Agency Comments

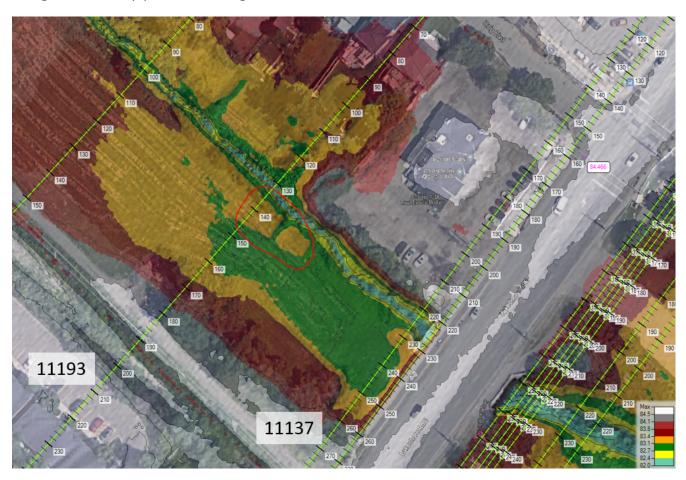
As we discussed at our last meeting on February 17th the proposed Lakeshore BRT project shows some flooding impacts on private properties upstream of the Lakeshore Rd Crossing of Serson Creek. We have taken the additional information you provided from that meeting and have been discussing it internally with our technical teams. The impacts as currently shown are not acceptable and CVC would not be in a position to support a project showing the current offsite impacts to private property. Our technical staff also discussed what solutions/opportunities might exist to help address/alleviate the flooding shown.

Our staff suggest exploration of three potential options to alleviate the increase in flood hazard due to the proposed culvert extension:

- 1. Floodplain cut on the west side of the creek immediately upstream of Lakeshore to provide additional floodplain storage;
- 2. Add a relief culvert to the Lakeshore crossing providing additional conveyance to the existing culvert;

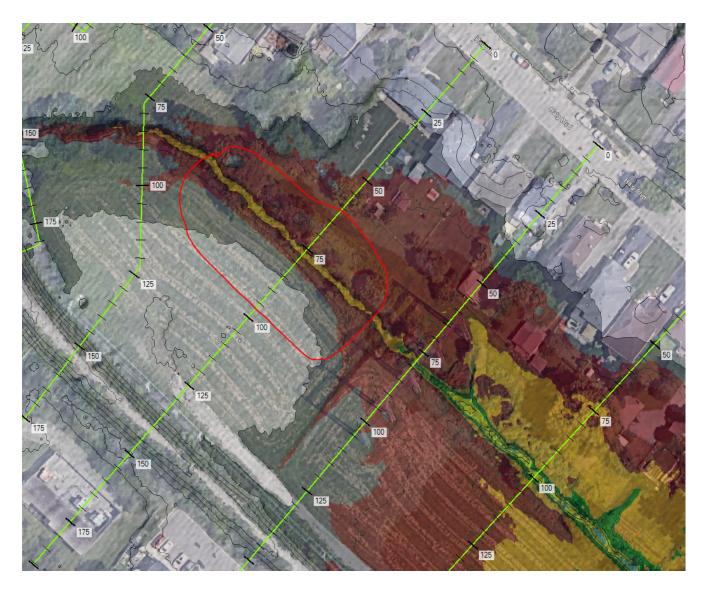
Some further thoughts on the above potential options. Although the floodplain is relatively flat on the west side of the creek, there is some potential for a gain in floodplain storage - note where the orange shading meets the dark green shading in the LiDAR image below. There may be some gain here in flood storage however, not enough to address the total current impact. The culvert is ultimately the hydraulic control to this system so the consultant may want to consider a combination of the options discussed above. Potentially a floodplain cut from XS 11137 to further upstream combined with a relief culvert or reduction in culvert length. The combination of the two might prevent any major alterations to the proposed culvert design. We do not have information on land ownership in this area and recognize this may pose a challenge on the west side of the creek.

Additionally, there is a point further upstream where the floodplain bottlenecks (see image below), pushing most of the flooding on to the residential properties. There could be additional opportunity to widen the floodplain at this location, however this may not be feasible for this project.

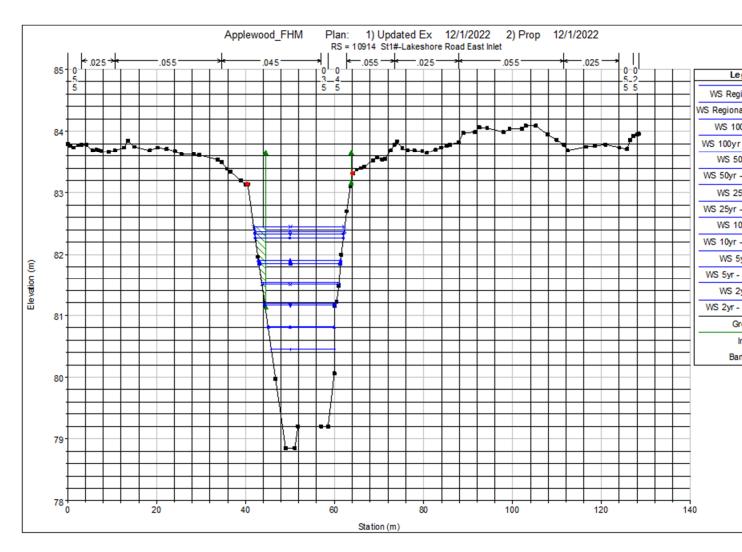
4. It appears that river station 10914 (immediately upstream of the Lakeshore Road crossing) demonstrates an increase in flood hazard for all modelled storm events. There is an increase of 0.074 m and 0.0686 m for both the regional and 100-year storms, respectively. This appears to be the only location showing an increase in flood hazard; however, all flooding is contained within the upstream valley. Please explain this increase and provide justification as to why this increase in flood hazard is necessary for the design. CVC does not accept any increase in flood hazard, unless adequately justified.
